BULLETIN

NUMBER 63

SUBJECT: Stabilizer Aluminum Yoke Casting

MODELS AFFECTED: J3 Series, Serial Nos. 6117, 6130, 6205, 6276, 6282 to 9101 (Incorporating Aluminum Yoke).

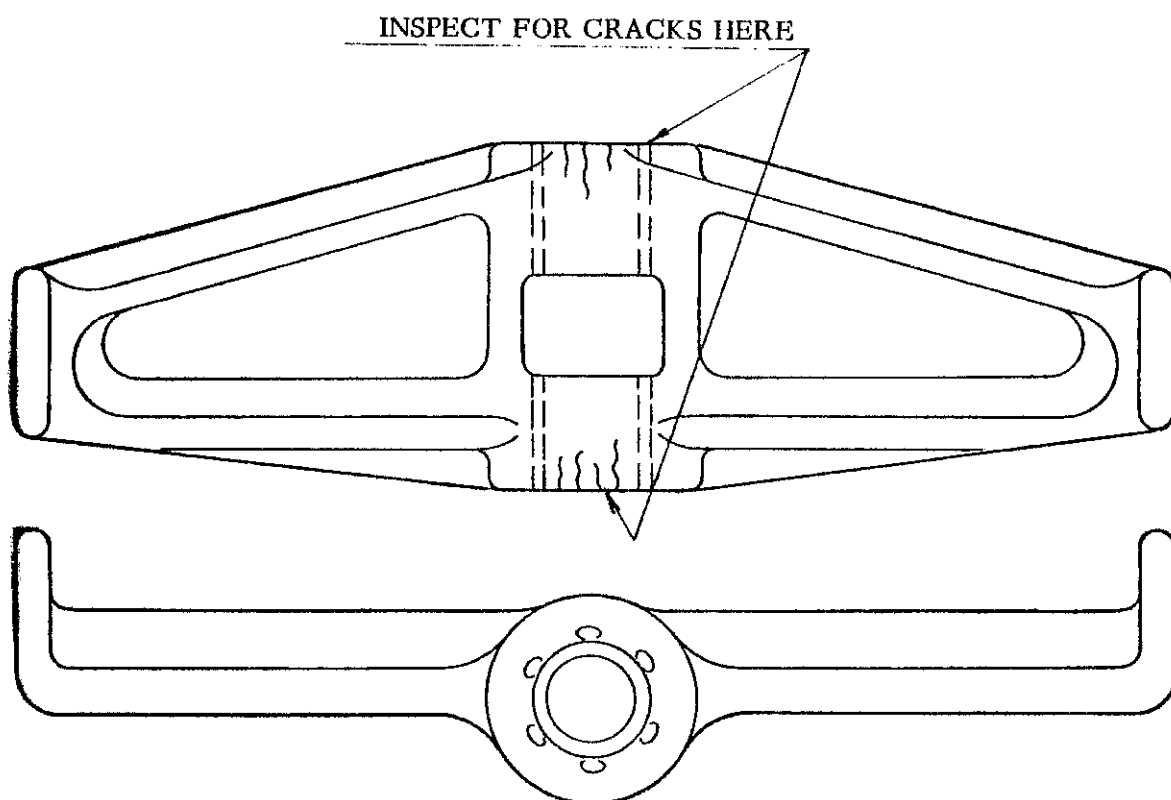
We have received reports of cracks occurring on the bosses thru which the stabilizer adjustment screw passes, in the stabilizer aluminum yoke casting, Piper Part No. 40791. (See Sketch).

As a serious accident may result from failure at this point, it is recommended that an immediate inspection be made of this casting in your airplane, and if any cracks are apparent, the part should be replaced before further operation of the airplane.

It is further suggested that this part of the plane be checked for cracks at the periodic inspections of the airplane in order to preclude a serious failure.

A log book entry of each such inspection should be made.
